Service Note		
Products	Description:	Service note no.
G-System GFX box RH450, RH750, Staccato, Classic450	PLCC socket broken	SNo-T206

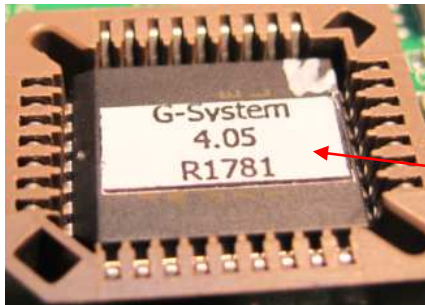
We have seen a few incidents where the sockets holding the flash were broken. It has been the small plate in the bottom, which were broken off. When this has happened and the flash IC is pressed all the way to the bottom of the socket is has none or bad contact to the contact springs in the socket. This can cause peculiar and weird errors, which most likely also can be intermittent. See pictures below:

Holdes for the bottom plate are broken off.

The IC pins gets poor or no contact to the socket contacts when pressed too deep into the socket

If you have one of the mentioned products in for service with an intermittent error, it could pay of to examine this socket. The quickest repair is to place a piece of 1 mm thick tape below the flash circuit. Please notice that not all Amp main boards have the flash in a socket.
